UNITED STATES PATENT AND TRADEMARK OFFICE

Office Action Summary

10/527,339

DETAILED ACTION

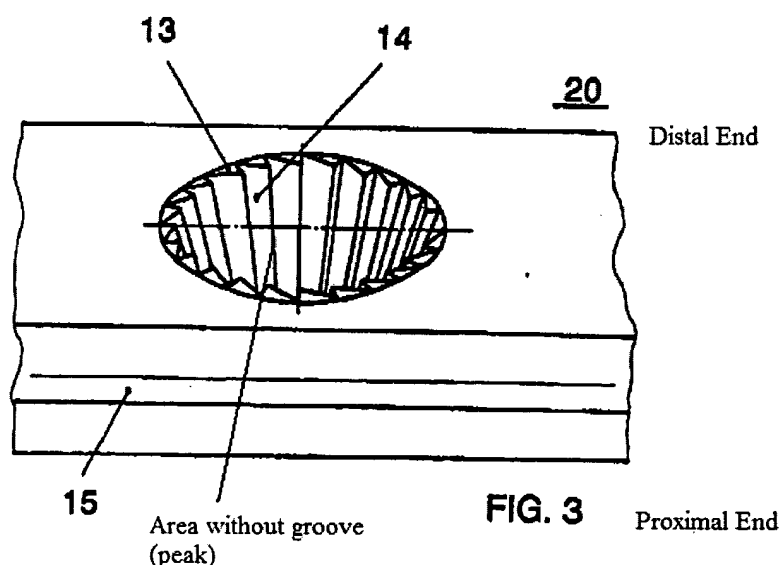
Gogolewski discloses a system including a vertebra plate 20, two openings 13 (see Figure 2) and a first fluting 14 (note the increasing fluting depth as shown in Figure 3 below). The system further includes a bone screw 10 having a screw head 3 and a threaded screw shank 1. The bone screw 10 also includes a second fluting 4 (note the varying depth along a length, as shown in Figure 1 b and 1 c, which also increases from each pole to the equator of the head). The openings 13 widen in a distal direction and can widen in a conical or dome-shaped fashion (see column 5 line 39). The first and second flutings 14 and 4 extend in a longitudinal direction and are wedge shaped wherein individual grooves are separated from each other (see column 6 lines 60-64, and column 2 lines 42-45). The flutings 14 and 4 further include areas without grooves disposed between the grooves (i.e. peak), and are structured and dimensioned to cooperate with one another (column 6 lines 60-64).
